CITY COUNCIL AGENDA ITEM

AGENDA ITEM: **201201766 (DRI)** - 4550, 4558, 4586, 4616 Roswell Road,
Applicant: JLB Partners, to rezone from A-1 (Apartment District) to
MIX (Mixed Use District) to allow a mixed-use development
(residential, office, and commercial), with a use permit and
concurrent variances

To: John McDonough, City Manager
 From: Angela Parker, Director of Community Development 
 Date: June 7, 2013 for submission onto the June 18, 2013 City Council meeting

Agenda Item: 201201766 4550, 4558, 4586, & 4616 Roswell Road a request to rezone the subject property from A-1 (Apartment Dwelling District) to MIX (Mixed Use District) with a use permit to exceed the district height, with a concurrent variance to allow 700 apartments, 90,000 square feet of retail/commercial and 30,000 feet of office.

SITE PLAN
SANDY SPRINGS GATEWAY
CITY OF SANDY SPRINGS
FULTON COUNTY, GEORGIA

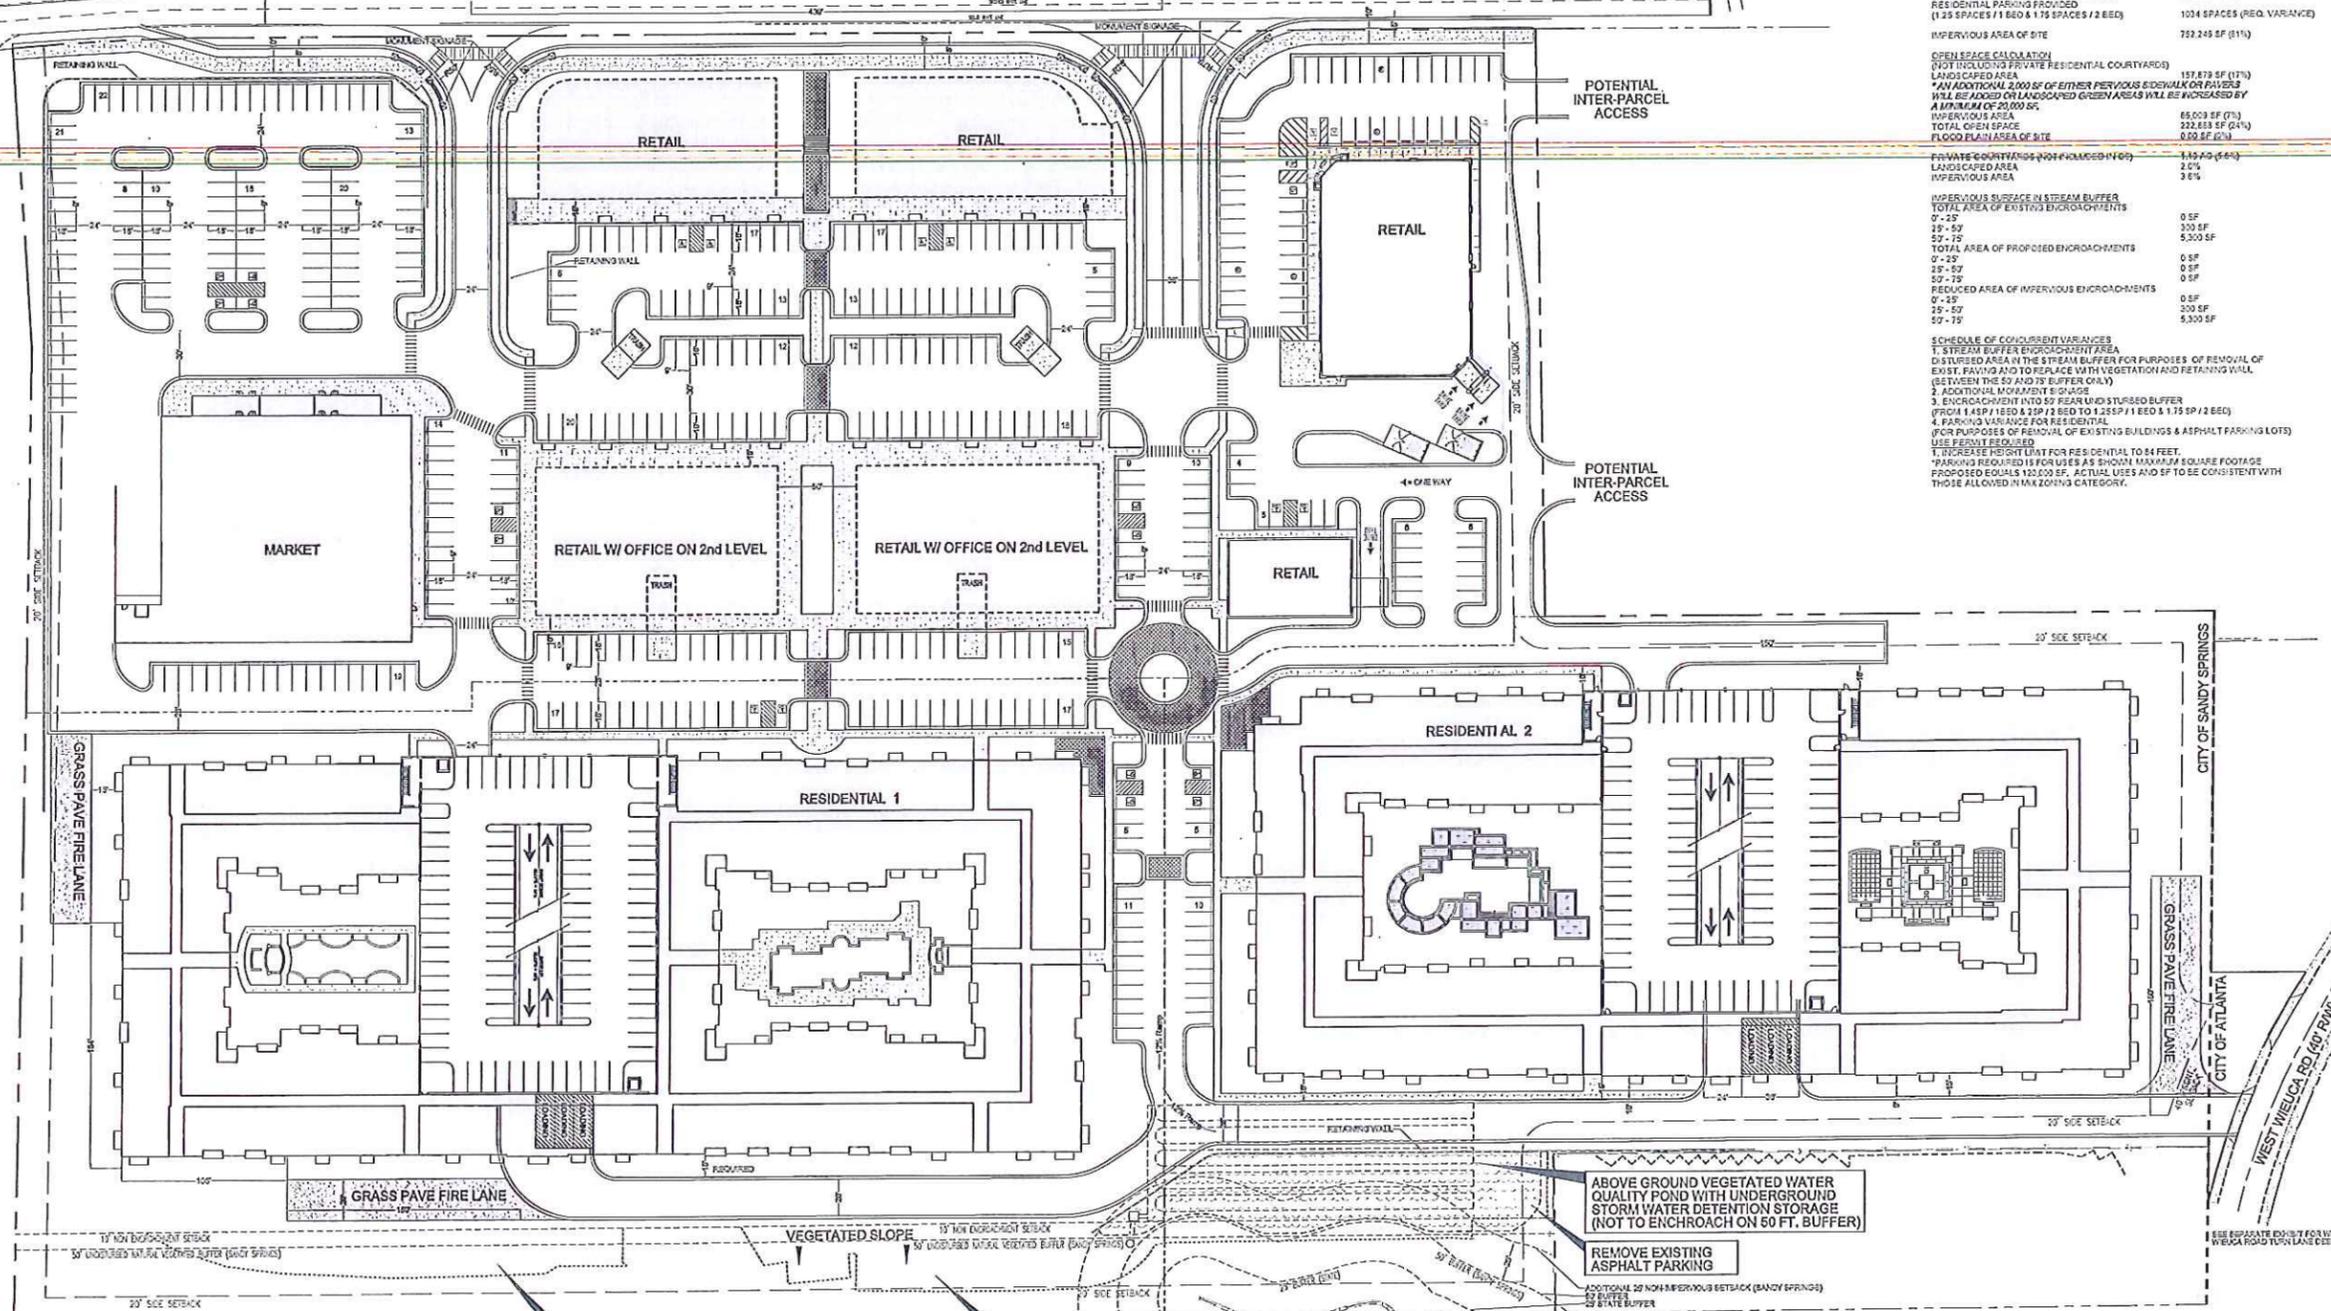
- d. The maximum building height shall be four (4) stories on the exterior of all residential buildings adjacent to single family residential properties along the west property line or 60 feet, whichever is less, for the residential building for Phase I and five (5) stories on the exterior of all buildings adjacent to nonresidential uses along the west property line, whichever is less, for the residential building for Phase 2 as shown on the site plan dated received May 7, 2013. (Use permit 201201766)

- b. To subject retaining wall shall be constructed in accordance with the proposed site plan, provided by the applicant dated received May 7, 2013 by the Department of Community Development, for the variance herein, showing a reduction in the 25 foot impervious surface setback to seventeen (17) feet to allow a retaining wall, where necessary to accommodate the portion of the encroachment only. (Variance 201201766)

07.27.2012
07.27.2012
PRELIMINARY SITE PLAN
PSP.0

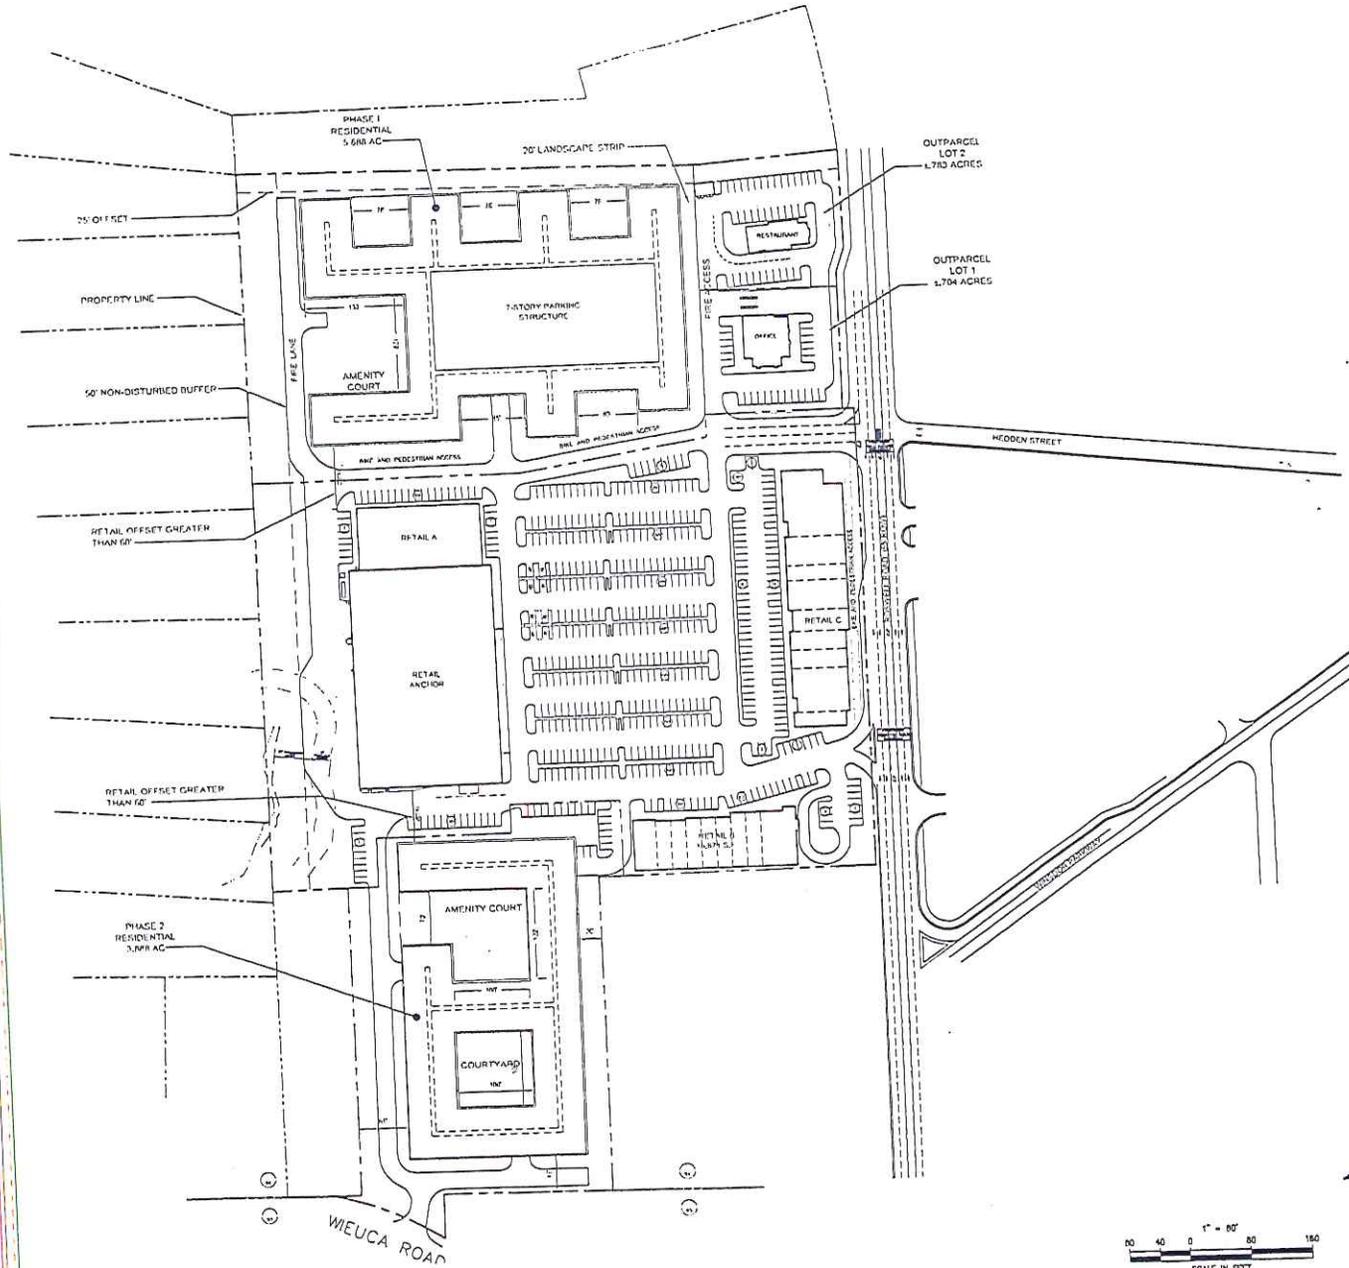
- The site plan presented during the pre-application meeting on July 30th, 2012 shows "Bike and Pedestrian Access" along Roswell Road in front of the "Retail C" building and not the entire frontage of the site. The developer should continue bike and pedestrian access along the entire Roswell Road frontage of the site.

- Inner-site connectivity and internal circulation is of concern. The site plan shows the center of the development as a large parking lot with no pedestrian facilities. Pedestrians need to be able to travel safely between uses/buildings within the site.
